CITY OF PORTSMOUTH, NEW HAMPSHIRE
Department of Public Works

Bid #14-09 School Door Replacements

Addendum #1

New Franklin School Front Entry

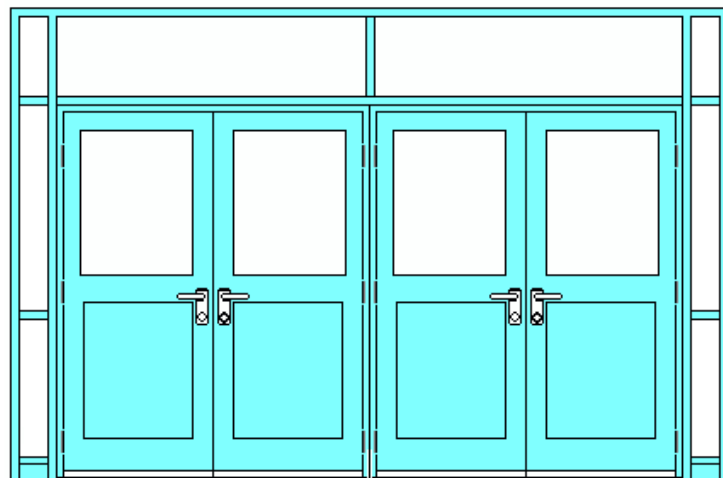
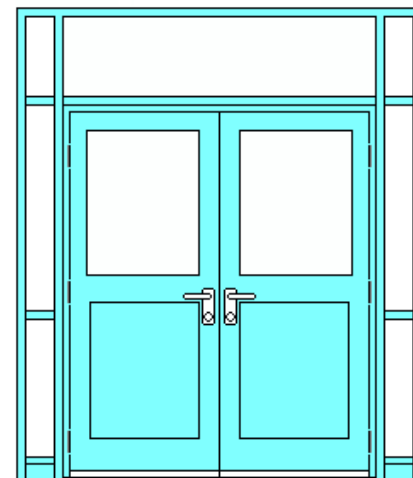
1. Quantities listed refer to pairs of doors, including frames.
2. Work includes all concrete repairs necessary to secure door frames to existing surfaces.
3. Keying of locks will be by others.
4. Replace transoms in all **D1** units. Change 34" doors to 36" doors at Sherburne School.
5. Replace transoms and sidelights at New Franklin School. Change 34" doors to 36" doors. Remove and reset all magnetic security contacts.
